Staff Report to the Plan Commission

Bridlewood Residential Planned Development

Project: 2025-0171 - Bridlewood Residential Planned Development

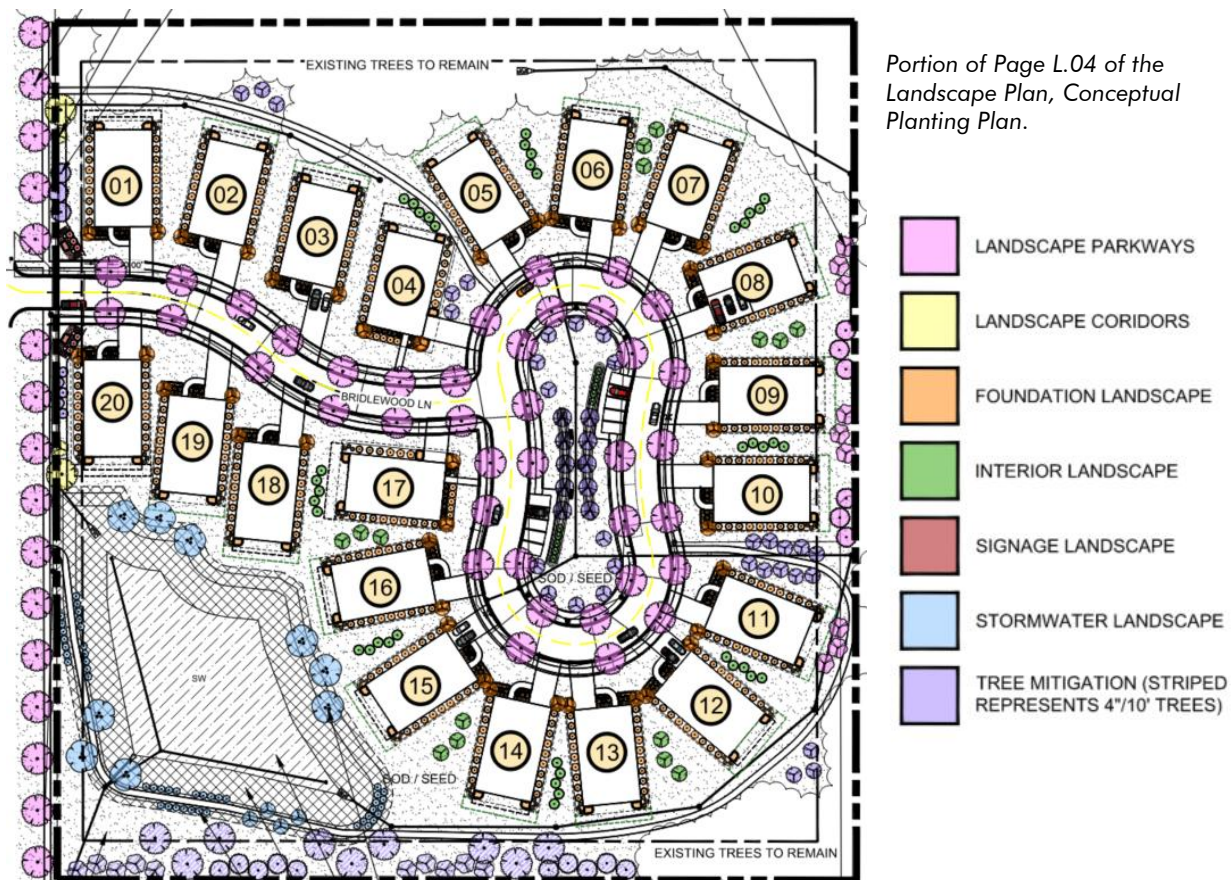
A existing wetland area is located within the northern portion of the proposed Planned Development. Per LDC Section 6-410.D.1, any activity occurring within 50 feet of a nontidal wetland requires a Special Use Permit. Page C3-0 of the civil engineering plans show the limits of

the existing wetland area, and Staff recommends approval of the requested Special Use Permit, as there is no disturbance to the actual limits of the wetland, but there are changes proposed within 50 feet of the wetland boundary.

A No Permit Required letter has been issued by the Army Corps of Engineers, outlining that there should be no impacts to the proposed wetland boundaries. The NPR letter states that no discharging of dredged or fill material is proposed into any aquatic resources subject to regulation under the Clean Water Act. Appropriate soil erosion and sediment control measures are required throughout construction of the proposed development. Potential impacts to the wetland buffer area, however, will require a WMO permit prior to final engineering approval.
